## **ADDENDUM NUMBER 2**

**BRADLEY ES & MARSHALL ES**  
**CANOPY REPLACEMENT**  
**Bid No. F13-07**

***SAN BERNARDINO CITY UNIFIED SCHOOL DISTRICT***

April 11, 2014

MARSHALL SITE PLAN

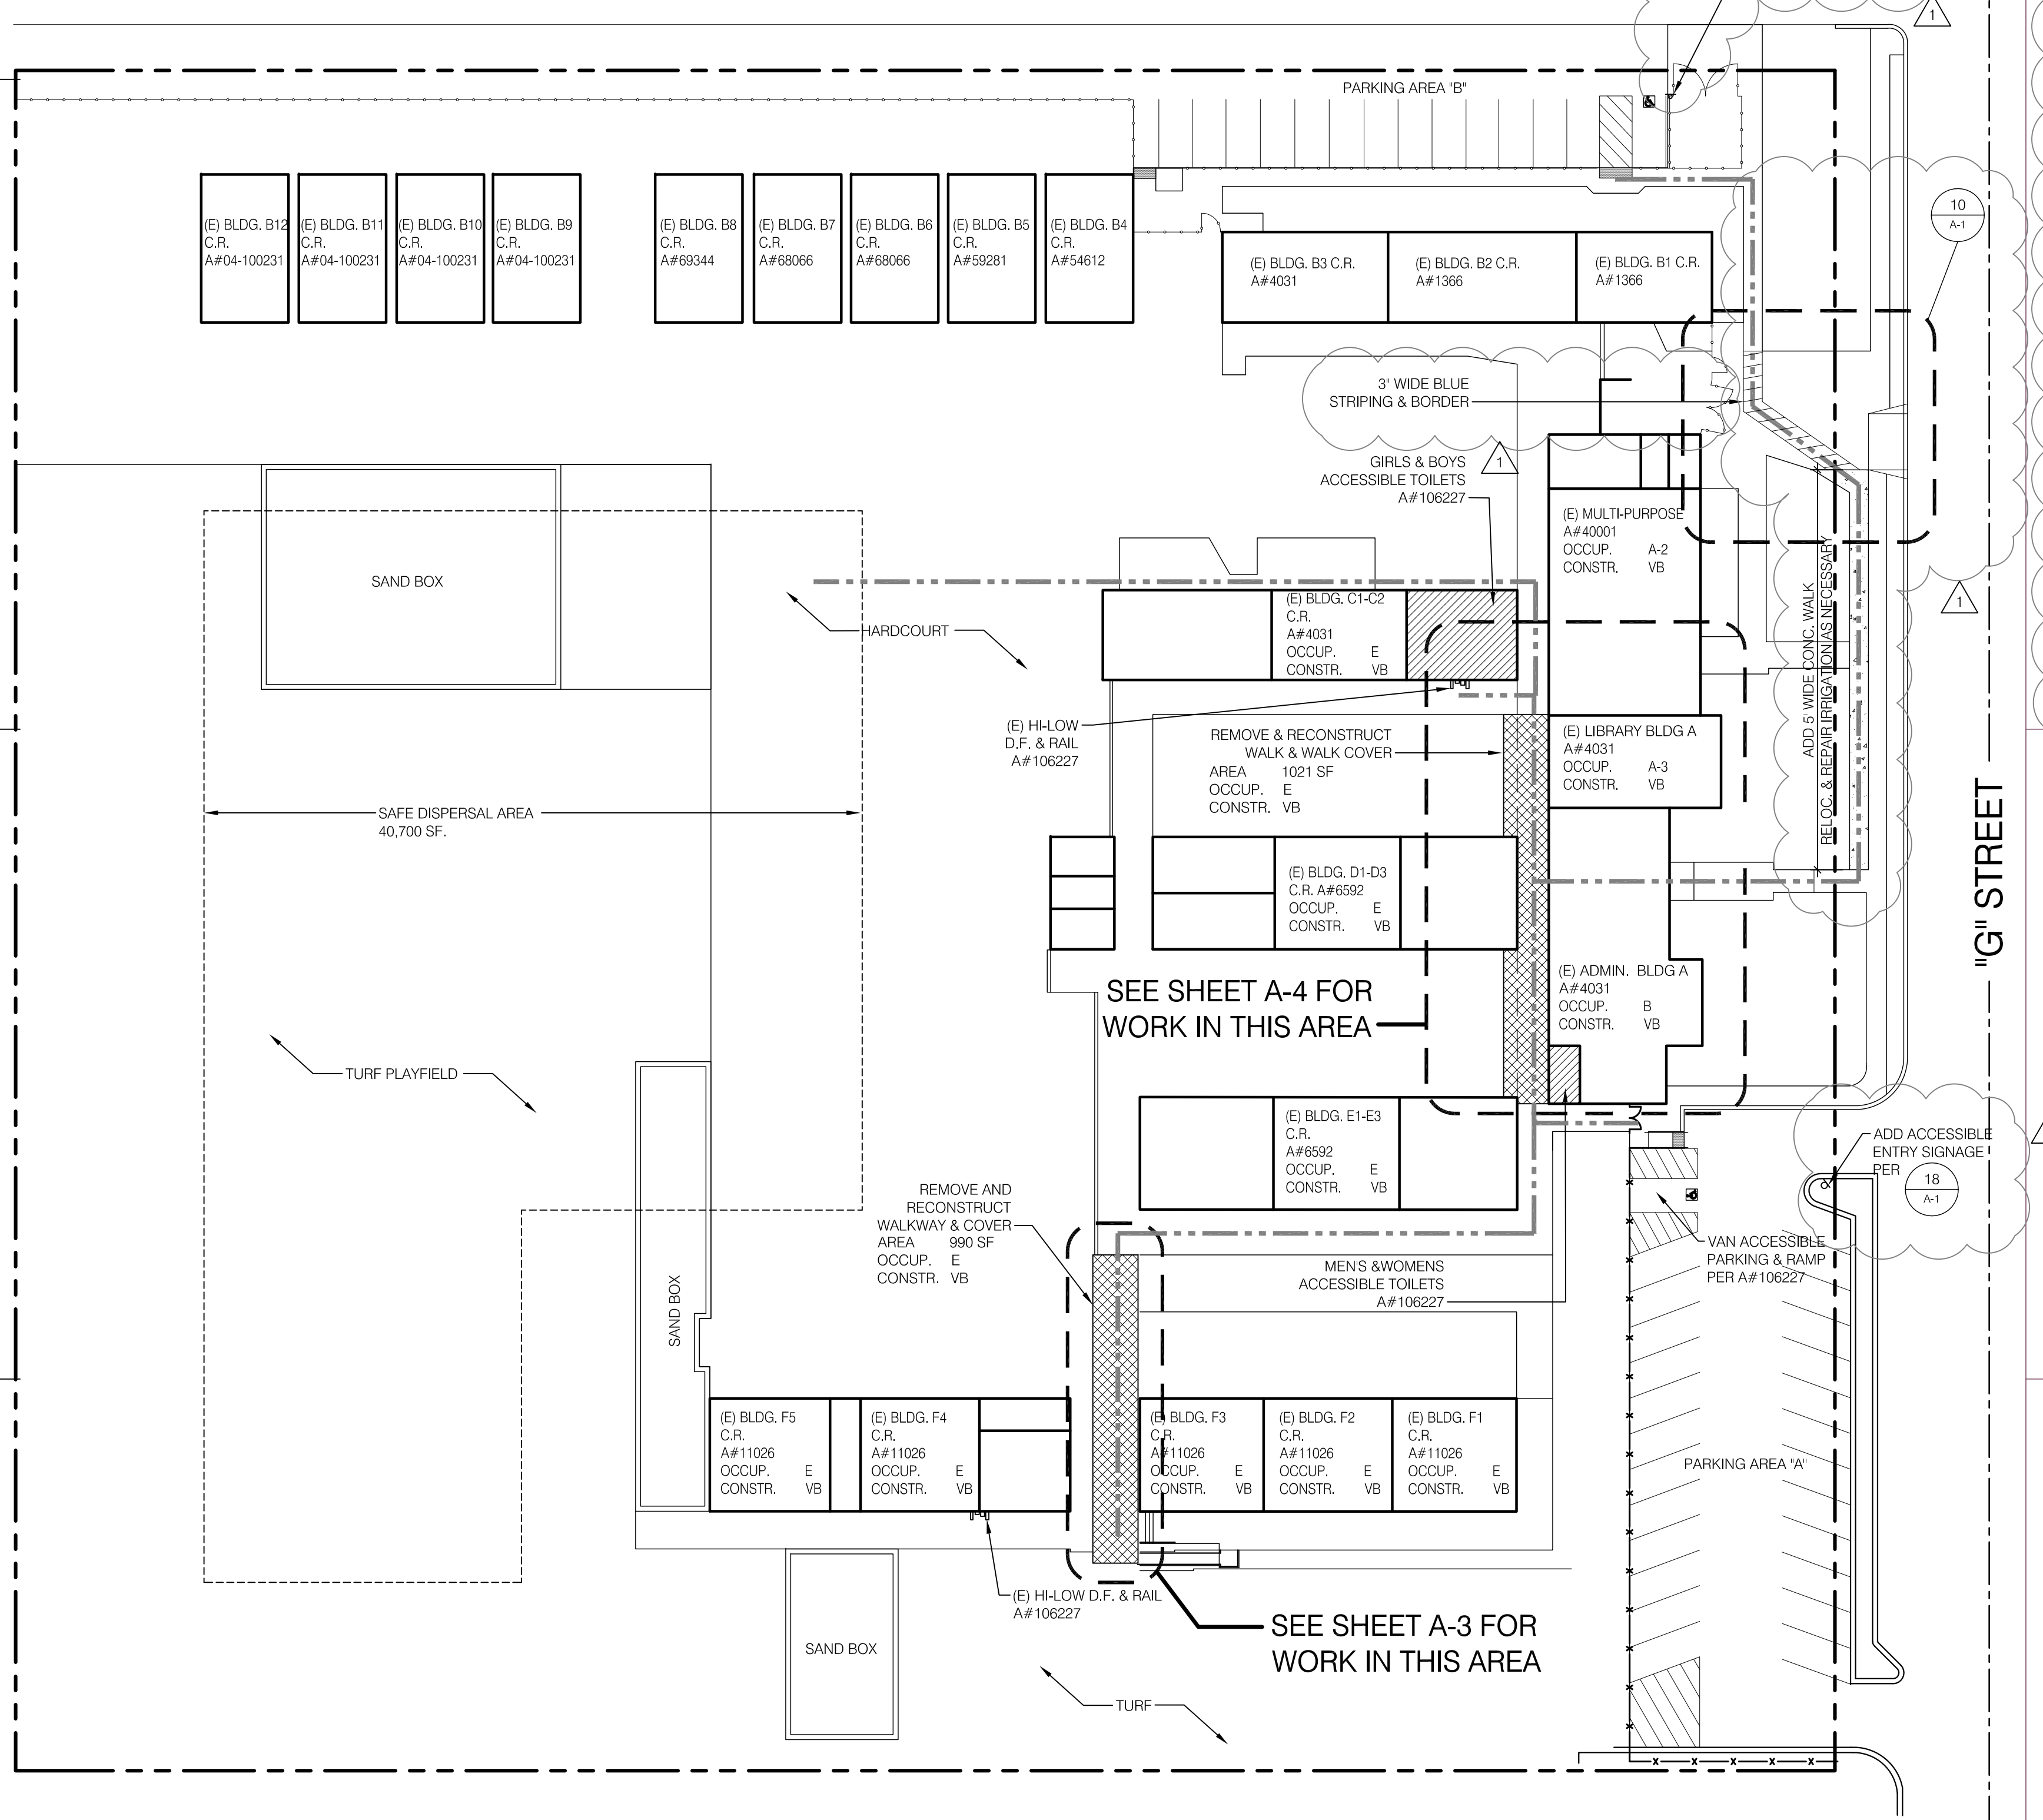
**Item Number 4;** Reference Marshall Sheet A-1 – Marshall Site Plan; Replace this sheet with attached sheet **A-1 – Marshall Site Plan.**

Note: Changes are identified by Delta 1 symbol.
